A Concerned Citizens Review of the Buffalo Municipal Watershed Project

By Craig Cope

January 23, 2023

Map 2. Proposed prescribed burning, hand thinning, and trails fuelbreak units within the project area.

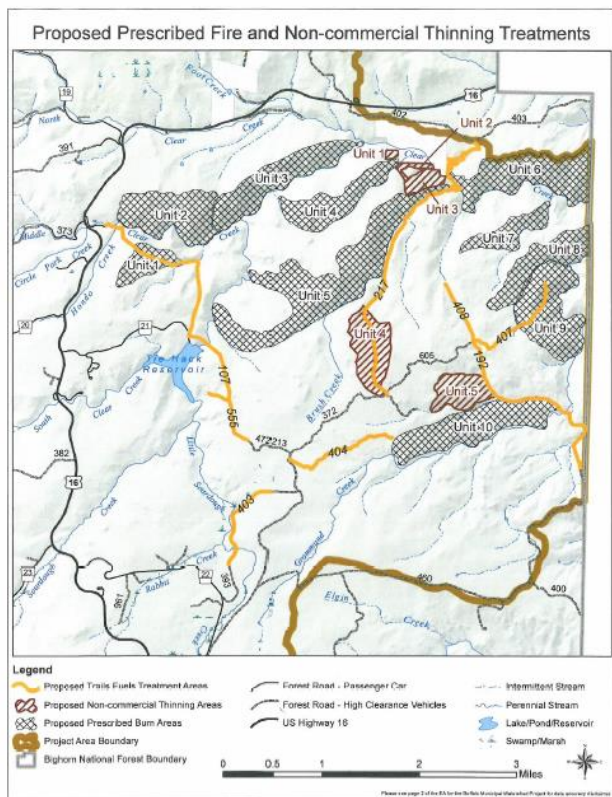
TR 107 Example of trails fuel treatment. Tree mortality caused by scorch from burning of slash pile too close to live tree.

In addition to the scorching of residual trees, the actual clearing was done on an old designated snow mobile trail not the original location of TR 107. The original location was east from now Camp Roberts downstream along Middle Fork of Clear. The route cleared for the BMW project was a designated snowmobile trail. The trail is still marked with the orange diamonds used for snowmobile trails. However, the 1993 Topographic map also shows the snow mobile trail as TR 107. Highly unlikely as just east of Camp Roberts the snowmobile trail leaves the drainage and climbs steeply, at least a 60% slope, out of the creek. A steep route works for a motorized users but not conducive for non-motorized users such as hike or horse use. The 1967 USGS topographic map shows a portion of TR 107 terminating at Middle Fork of Clear Creek.

Mechanical Timber Harvest Treatment Map

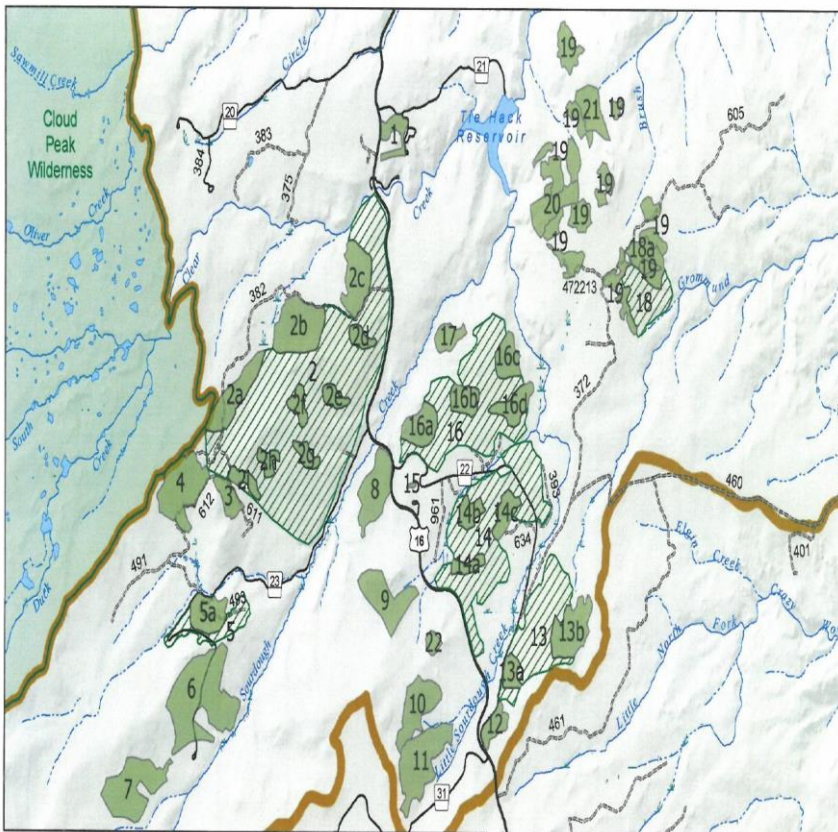
Unit 2C bordering FDR 382. This cut is part of the 370 acres of clear cuts for Unit 2a, 2b and 2c. Example of what the clear cuts look like.

Unit 6 near the end of FDR 23, Sourdough Road. Unit is 150 acres. Another example of the resulting clear cuts.

Unit 1 near Tie Hack Campground. BMW EA stated this unit was to have 60 feet by 60 feet spacing.

East end of Unit 1. Note blowdown occurring into Tie Hack Campground.
